# STAFF REPORT

## REGIONAL CENTER HEARING EXAMINER - HIGH IMPACT CASE

<b>Case Number</b>	2024-REG-055
<b>Address (approx.)</b>	2163 and 2179 North Illinois Street
<b>Location</b>	Center Township, Council District #12
<b>Petitioner</b>	Near North Development Corporation, by Audra Blasdel
<b>Zoning</b>	MU-2 (RC); D-8 (RC) (pending)
<b>Request</b>	Regional Center Approval to provide for a 20-unit townhome development, consisting of six buildings.

Landscape plan

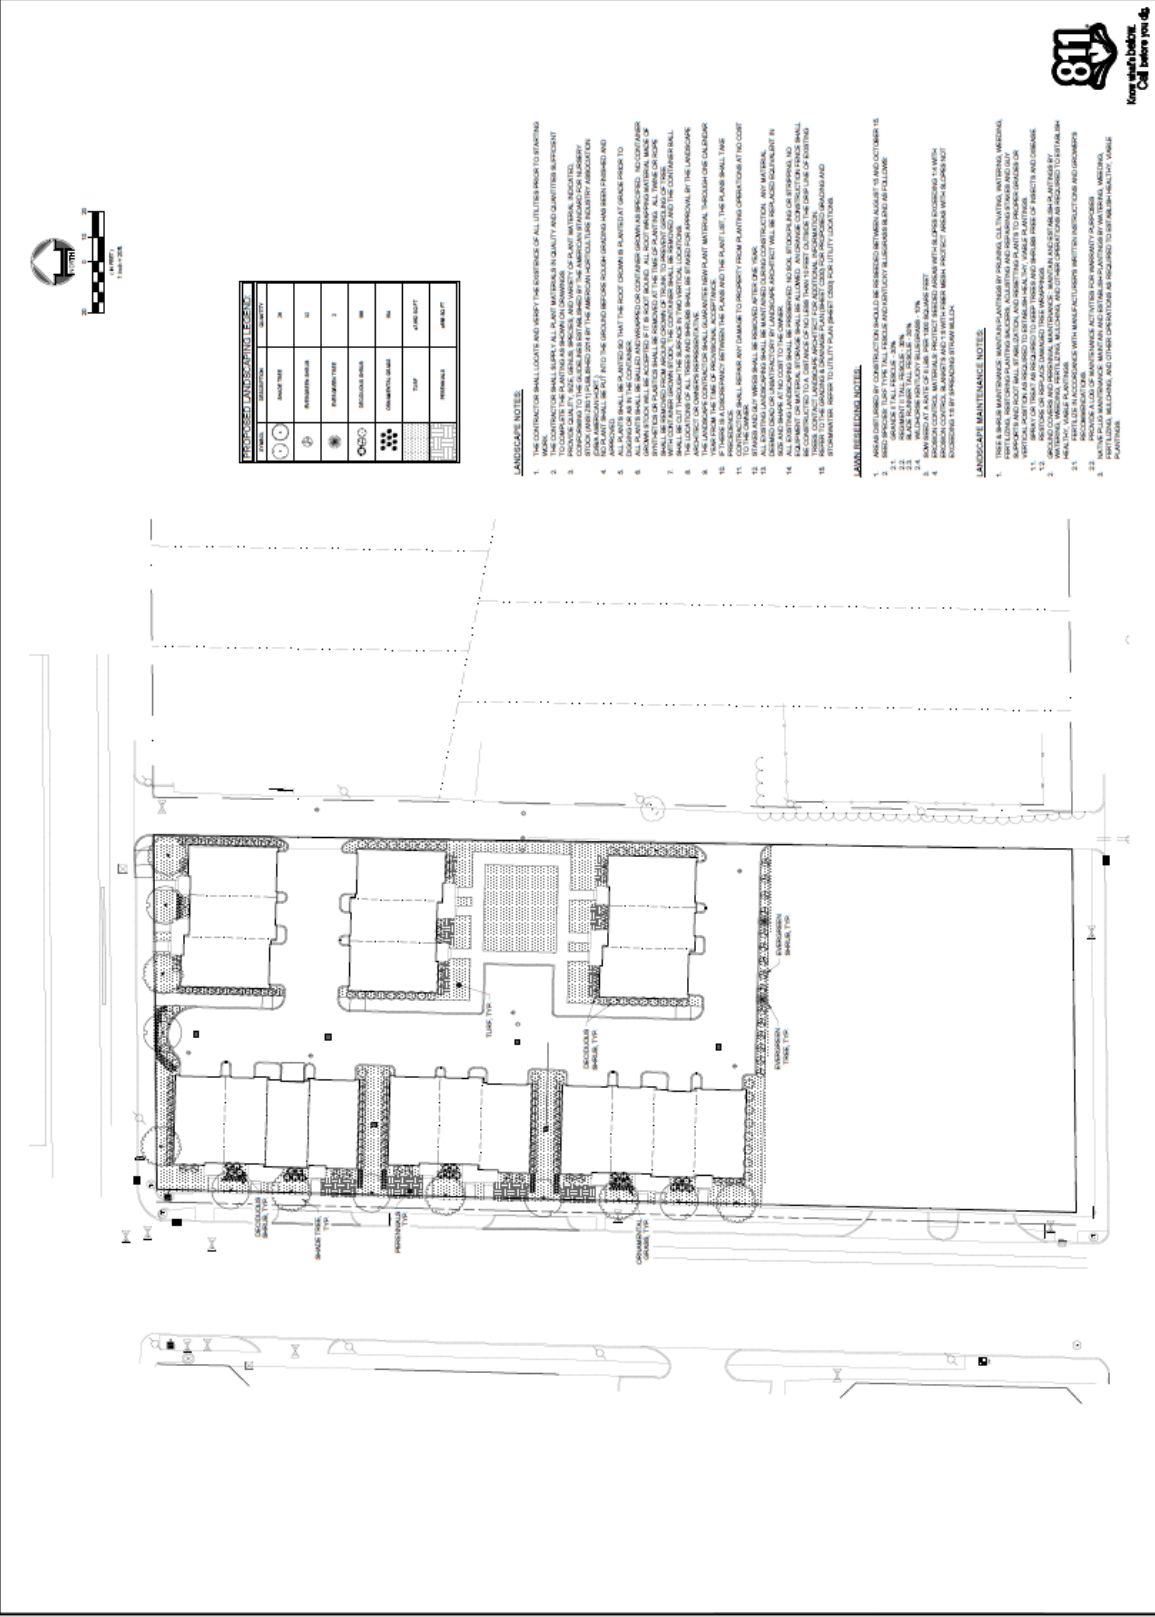
3. A preliminary landscape plan was submitted; however, plant species plans were not submitted. Staff would specifically request additional trees to be added to open areas within proposed grass areas. Therefore, a detailed landscape plan, with plant species types, must be submitted prior to the issuance of an Improvement Location Permit. Guidelines US 1.3.2, CA 4.6.1, CA 4.6.4, and CA 4.6.5 would apply.
